Item Name: Crosstube Turning Detail

DART AEROSPACE LTD		Work Order:	76344
Description: Crosstube Assembly (412 High Aft)		Part Number:	D412-664-243
Inspection Dwg: D412-664-243 Rev: E		Page 1 of 1

DRAWING NO. D412-664-243	TITLE CROSSTUBE ASSEMBLY (412 HI AFT)	REV. E	DART AEROSPACE LTD ENGINEERING ORDER		D.E.O. NO. D412-664-243-E-1	SHEET NO. SHEET 1 OF 2	SCALE NTS
DRAWN	CHECKED	MFG. APPR.	APPROVED	DE APPR.			
DATE 11.03.31	DATE 11/03/31	DATE 11.03.31	DATE 11/03/31	DATE 11.03.31

DRAWING NO. D412-664-243	TITLE CROSSTUBE ASS'Y (412 HI AFT)	REV. E	DART AEROSPACE LTD ENGINEERING ORDER		D.E.O. NO. D412-664-243-E-2	SHEET NO. SHEET 1 OF 1	SCALE NTS
DRAWN P	CHECKED AS	MFG. APPR. E	APPROVED MP		DE APPR. H		
DATE 11.09.07	DATE 11.09.19	DATE 11.09.19	DATE 11.09.19		DATE 11.09.19

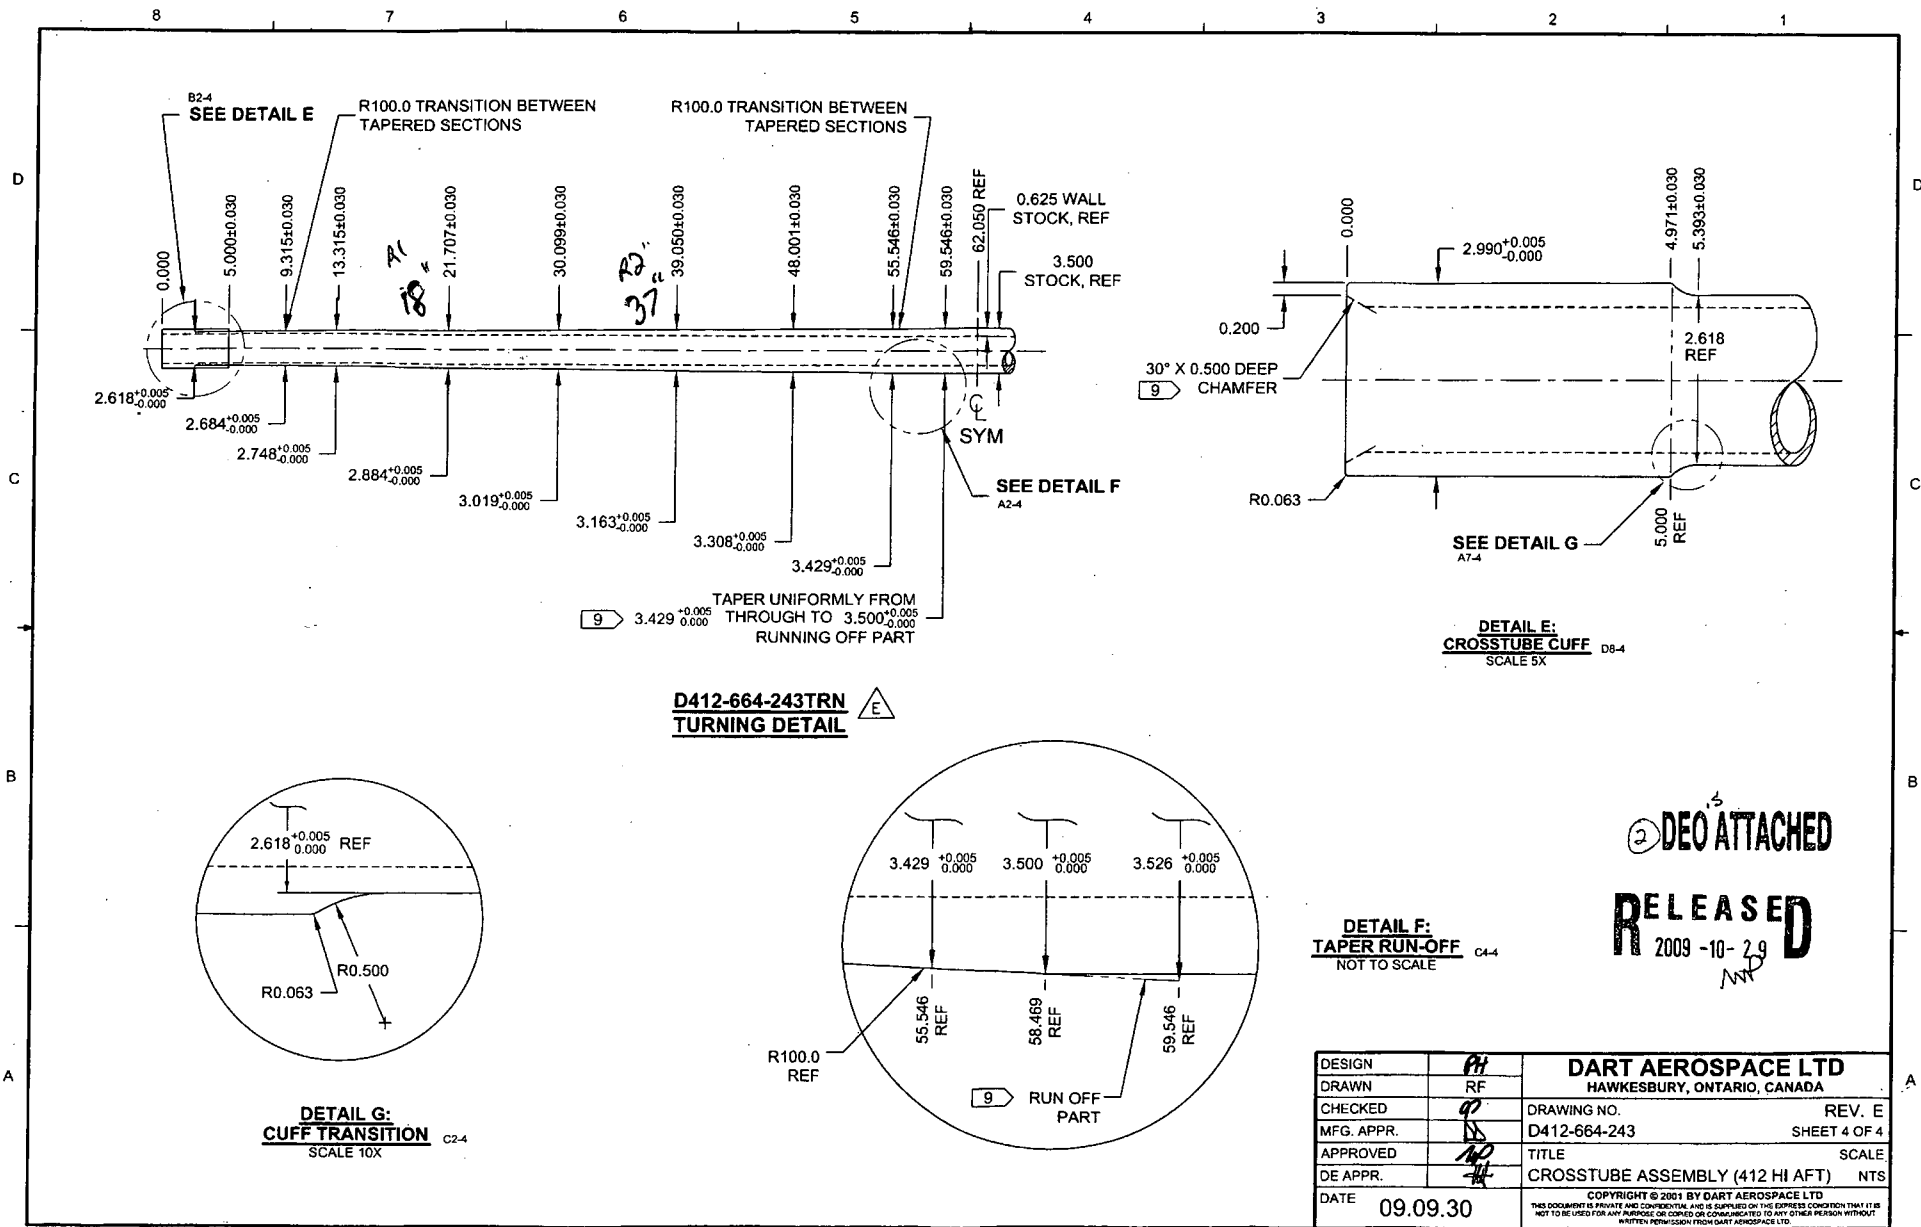
REMOVED ABRASION STRIP IN FAVOR OF A THIN LAYER OF PROSEAL 890.

D3189-1 CHAFING SHIELD (1, INSTALLED OVER PROSEAL 890)
MS21920-28 CLAMP, 2X
2 PL

D2856-600-1009 ABRASION STRIP
D3189-1 CHAFING SHIELD (1, INSTALLED OVER ABRASION STRIP)
MS21920-28 CLAMP, 2X
2 PL

MASK AREA PRIOR TO PAINTING AND
APPLY CLEAR COAT AFTER PAINTING
